## Technical Service Bulletin (TSB)

### Flash: Electric Power Steering (EPS) Module Updates

| REFERENCE:         | TSB: 08-148-23 REV. A<br>GROUP 08 - Electrical                                                                                                                                                                                                                                                                                                                                                                                                                                                                                                                                                                                                                                              | Date: | June 23, 2023 | REVISION:                                                                                                                                                                                                           | 08-148-23 |
| VEHICLES AFFECTED: | 2023 (GG) Dodge Hornet<br>This bulletin applies to vehicles built on or before May 30, 2023 (MDH 0530XX).

**Fig. 1**  
**Example of wiTECH Step Flashes**

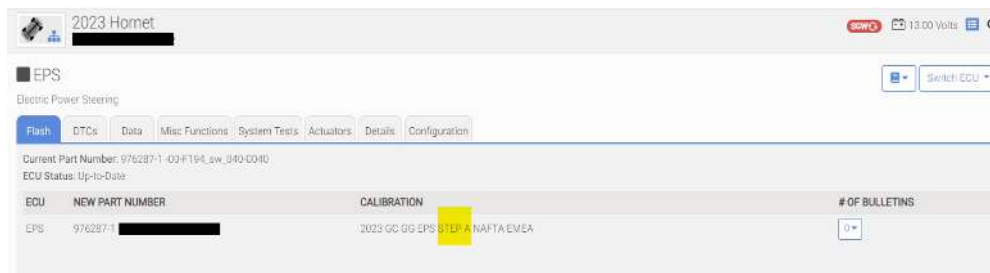
**CAUTION! \*\*Multiple step flashes up to three may be necessary and are required to completely update this EPS these must be performed in order starting with STEP A or B and ending with Step C, be sure to follow wiTECH accordingly (Fig. 1) .\*\***

3. **\*\*Select the appropriate software per wiTECH (Step A, B or C) either Step A or B must be done first in order and end with Step C when finished.\*\***
4. Reprogram the EPS module with the latest software. Detailed instructions for flashing control modules using the wiTECH Diagnostic Application are available by selecting the application's "HELP" tab.
5. Wait 2 minutes after the EPS flash has been completed.
6. To perform an EPS reset with wiTECH - Go to the Guided Diagnostics menu --> Select Reset ECU --> Select "EPS" from the list of modules --> Click "Continue" at the bottom of the page then follow the wiTECH prompts.
